SUMMARY OF THE ACTION

Patent Application Ser. No.: 10/776,325
Response to the Final Office Action dated June 9, 2006

Annotated Sheet

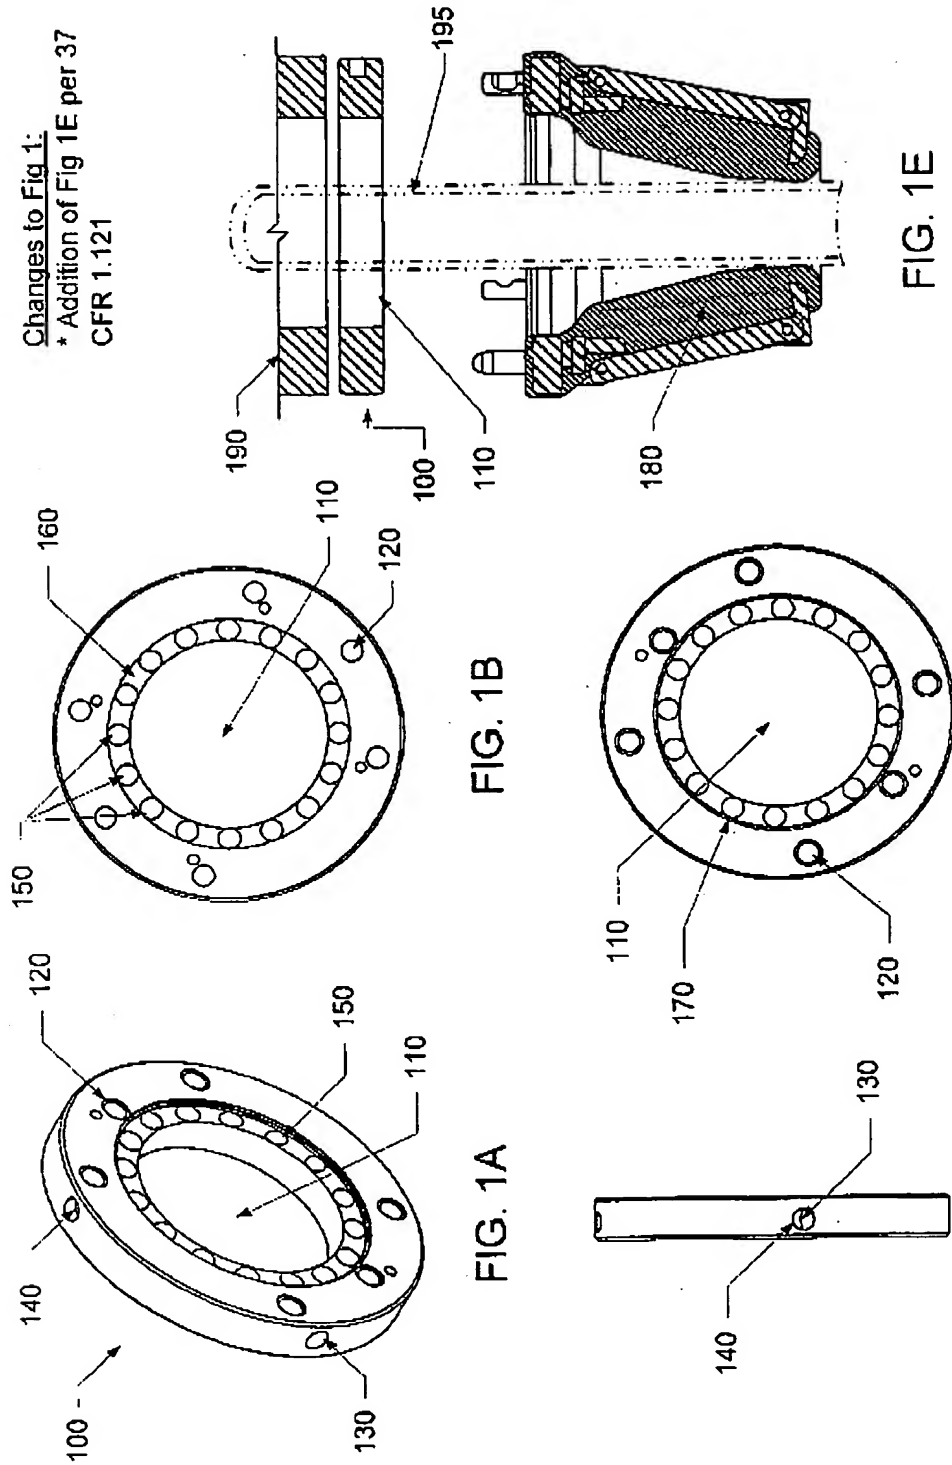
The drawings are objected to by the Examiner under 37 C.F.R. 1.83(a). Corrected drawings are required that show the stripper rubber, drilling head equipment and the down hole tubular. The objection to the drawings will not be held in abeyance and no new subject matter should be entered.

Changes to Fig. 1:
* Addition of Fig 1E per 37
CFR 1.121

A replacement drawing sheet and an annotated drawing sheet for Figure 1 are submitted herewith to overcome the objection to the drawings. No new subject matter has been entered. Entry after final of the corrected drawing is respectfully requested.

Corrected Figure 1 includes Fig. 1E which shows adapter 100 together with the stripper rubber, the drilling head equipment and the down hole tubular.

It will be noted that the corrected drawing at Fig. 1E includes reference numerals to indicate the stripper rubber, the equipment and the down hole tubular. These reference numerals have been included for the convenience of the reader of the patent and, as explained above, do not inject any new subject matter in to the application but merely provide context to the elements of the drawing which are supported by the applicant's specification. The applicant therefore respectfully requests that the reference numerals not be deemed to be new subject matter and that they also be entered after final along with the corrected drawing.

[0026] Fig. 1E is an exploded side view cross-section of a stripper rubber connection to drilling head equipment with an adapter of Fig. 1A. Adapter 100 connects to stripper rubber 180 as described herein below and connects to

equipment 190 also as described herein below. Down hole tubular 195 extends through equipment 190, adapter 100 through bore 110 and stripper rubber 180.
